Determination 2019/019

Regarding the code-compliance of a proposed residential pool barrier at 11A Hanene Street, St Heliers, Auckland

Summary

Figure 1: Site plan (not to scale)

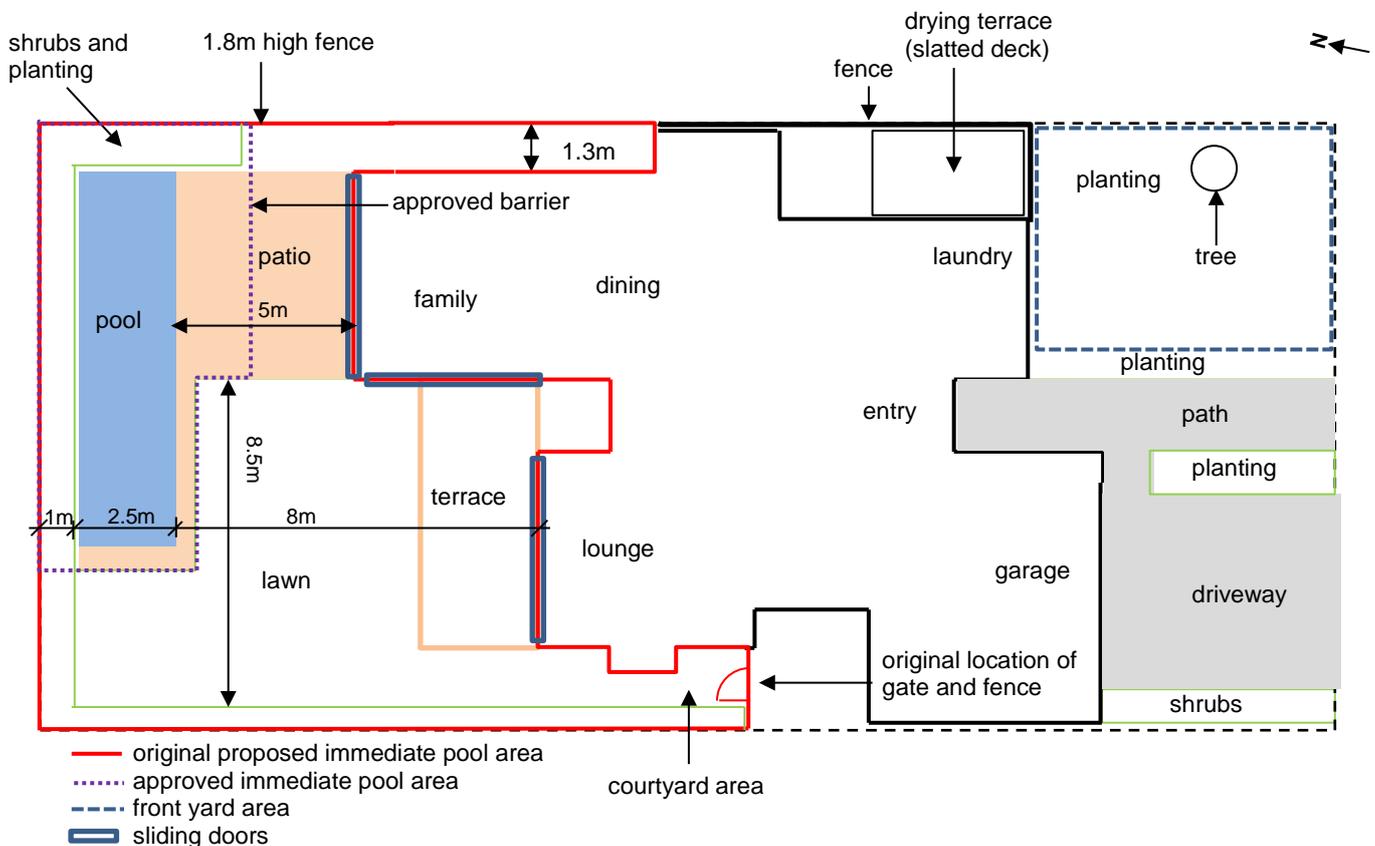
- 2.1 The building work that is the subject of this determination is the proposed barrier around a swimming pool the applicant is planning to build on the property. The applicant advises the total area enclosed by the proposed barrier would be around 150m². In addition to the pool, this area would contain a paved patio and a wooden terrace, some raised gardens along the fence line, and an area of lawn (see Figure 1).

- 2.3 The plans originally submitted in the proposal for the amendment show a 1.8m high fence with a gate opening into the pool area on the western side of the house where there is an approximately 2m gap between the house and the boundary fence. The plans also show a 1.3m wide gap between the house and the boundary fence on the eastern side (see Figure 1), which was not separated from the immediate pool area.

- 2.4 The southern side of the pool barrier is proposed to be formed from the external walls of the applicant's house as shown in Figure 1. These walls have three sets of existing sliding doors within them, which as part of the proposed amendment will be fitted with a proprietary self-closing and self-latching mechanisms ("the mechanism"). Two sets of the sliding doors lead from the existing paved patio and lawn into what is described on the plans as the applicant's family room. The third sliding door leads from the existing terrace into the lounge. The sliding doors are approximately 2.6m in height, and all have two sliding leaves and one fixed leaf.

- 5.2.13 Taking into account these factors, I am of the opinion that the area proposed to be enclosed by the pool barrier cannot properly be described as “the immediate pool area” and for this reason the proposed barrier does not comply with Clause F9 of the Building Code.

- 5.2.17 In addition, the proposed immediate pool area includes sections around the east and west sides of the building that is not easily observable from the main pool area. A supervising person in this area will not be aware of children and their activities in the immediate pool area and vice versa. I note that the applicant has indicated this concern will be addressed through the inclusion of gates to exclude these areas from the immediate pool area.
